WEST CAMBRIDGE

Planning Application Update

DRAFT
for Consultation

West Cambridge WC/OPA/PAR/05 - Maximum Building Heights Parameter Plan

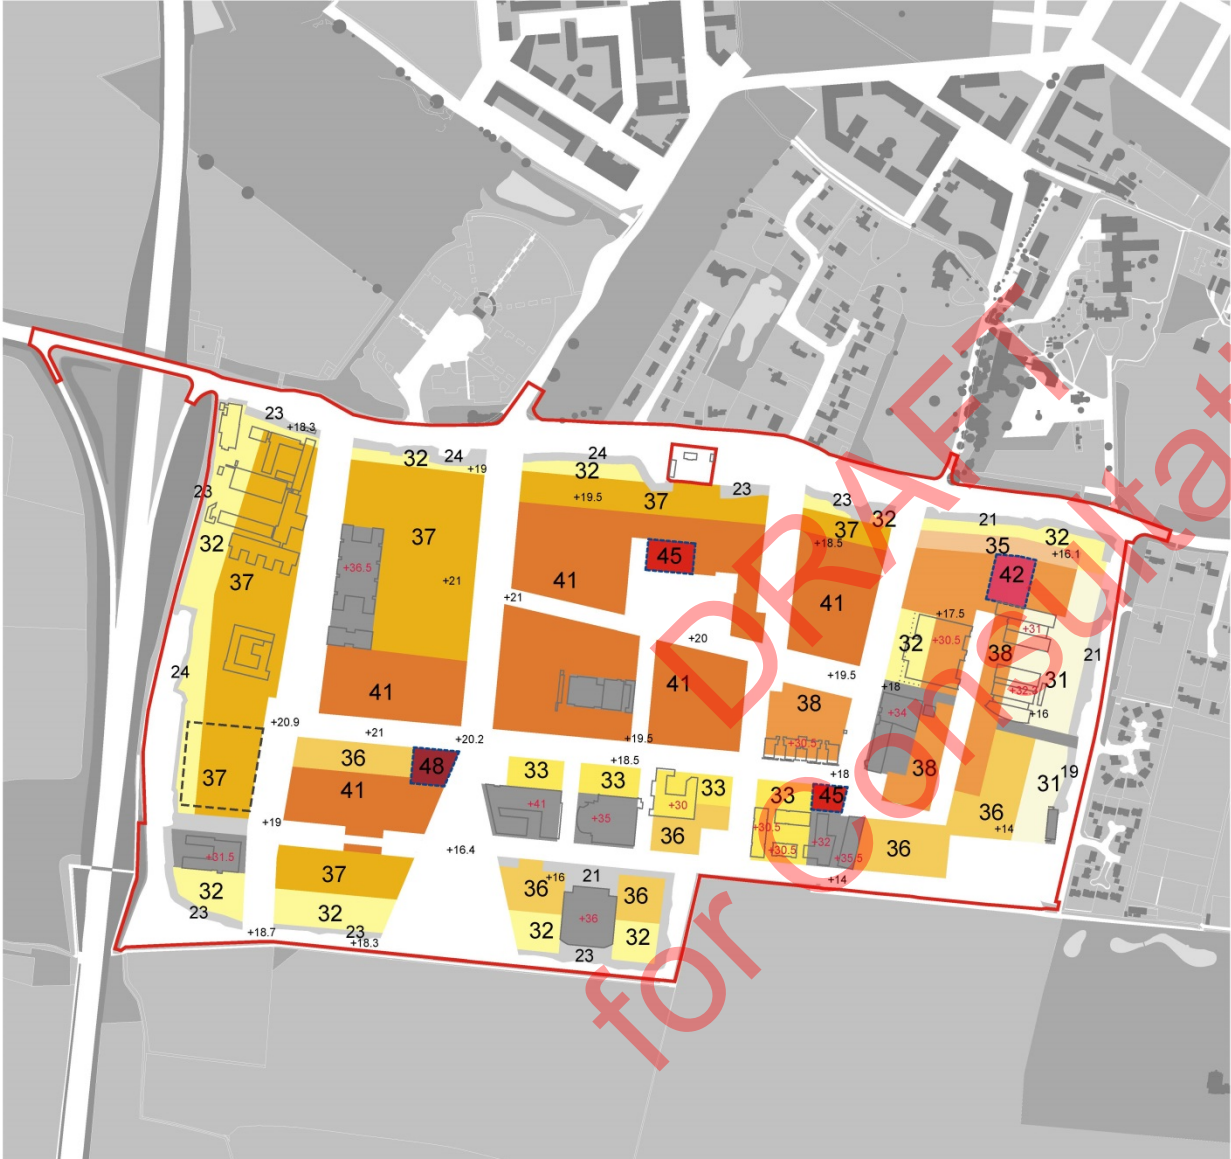
- We have reviewed the height parameters in discussion with Cambridge City Council and have:
 - reduced the number of taller elements from 10 to 4, with reduced heights from 49m to 45m; to 48m, 45m and 42m (AOD)
 - reduced the heights along the southern edge by up to 5m
 - reduced the height along the eastern edge by between 2m and 4m
 - added a 32m AOD setback zone along the western edge
 - reduced the height along Charles Babbage Road by between 4m and 8m

Tree Retention

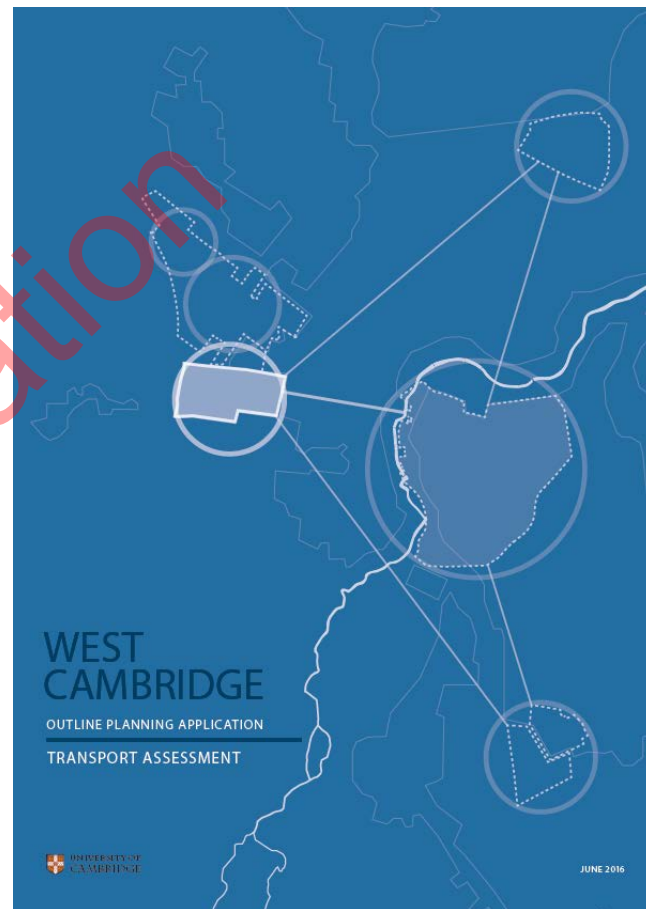
- We have:
 - Reconsidered potential for retention of existing trees onsite - revised Tree Retention Plan
 - Identified appropriate buffer zones between existing trees and the proposed built development

Access / Servicing from Clerk Maxwell Road

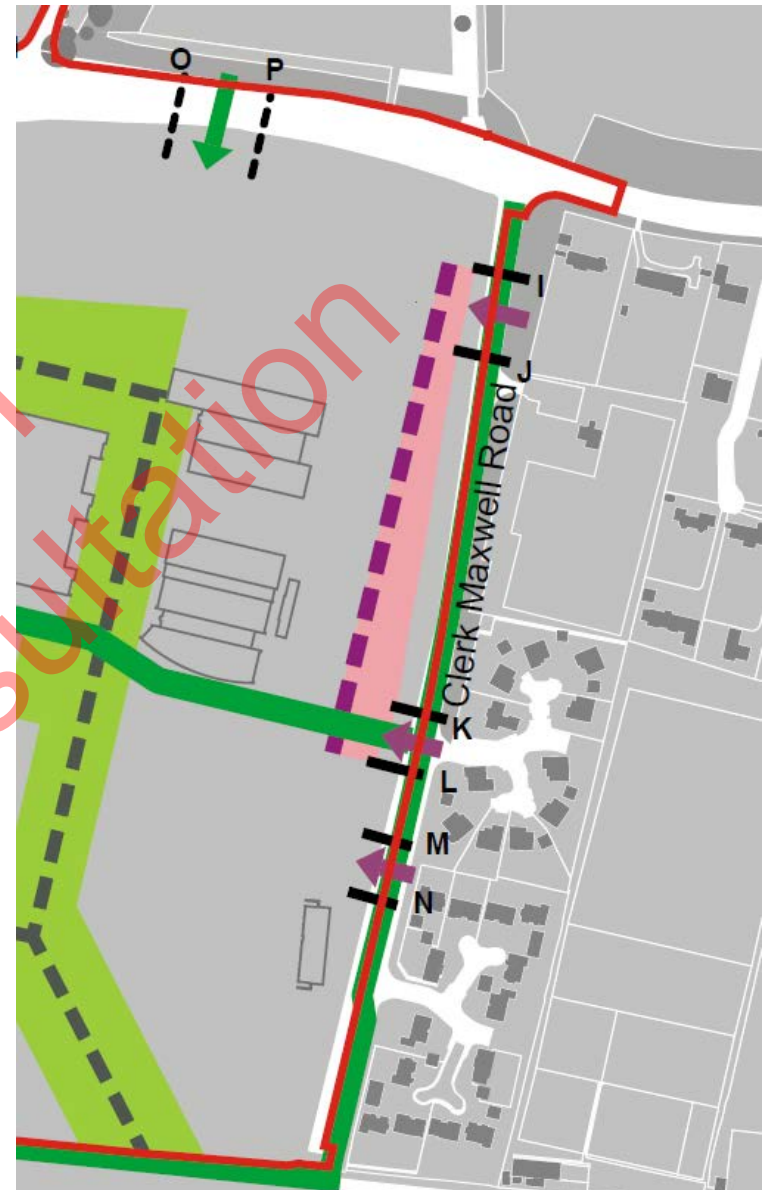
- We are considering reducing the size (capacity) of the proposed multi-storey car park off CMR
- We are clarifying access/servicing proposals:
 - These access points are for servicing / access to buildings east of JJ Thomson Avenue only - will not provide any through routes to the wider site
- Planning consent is sought for:
 - Access/egress I-J
 - Egress K-L to provide flexibility (egress only). The University will confirm at Reserved Matters whether or not K-L is required.
 - Access/egress M-N will only be implemented with redevelopment of the current Cavendish site (longer term)
